Staff Report & Recommendation

Historic Preservation Board

SUBJECT: HPB20-0390, 4441 Collins Avenue.

An application has been filed requesting a Certificate of Appropriateness for modifications to the existing Tresor Tower including the construction of a new ground level vertical circulation structure in order to facilitate the construction of a new pedestrian bridge over the 44th Street right-of-way connecting the subject property to 4360 Collins Avenue, including variances to reduce the required street

Proposed connection plan: 4th level Tresor Tower parking garage to 3rd level ballroom structure

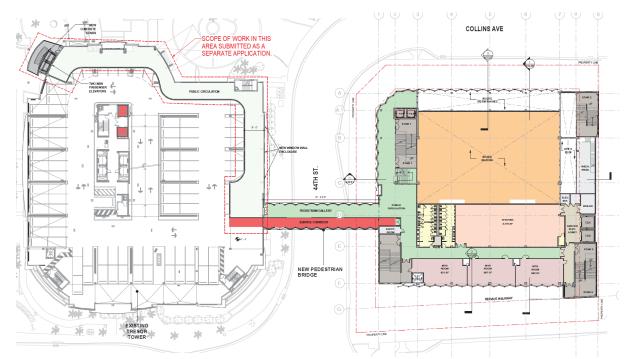
The applicant is currently proposing to construct a stair and elevator addition at the northeast corner of the Tresor Tower. This addition will allow for a direct connection from the hotel to the new building via a new enclosed walkway at the fourth level of the Tresor Tower parking garage and a proposed pedestrian walkway over 44th street. In connection with the enclosure of a portion of the parking garage for a new walkway, certain existing louver openings along the perimeter of the parking level will be converted to windows.

The application is fairly straightforward, and staff has no design concerns. Further, the proposed modifications will not have any adverse impact on the historic structures on site or the surrounding historic district. As such, staff recommends approval as noted below.
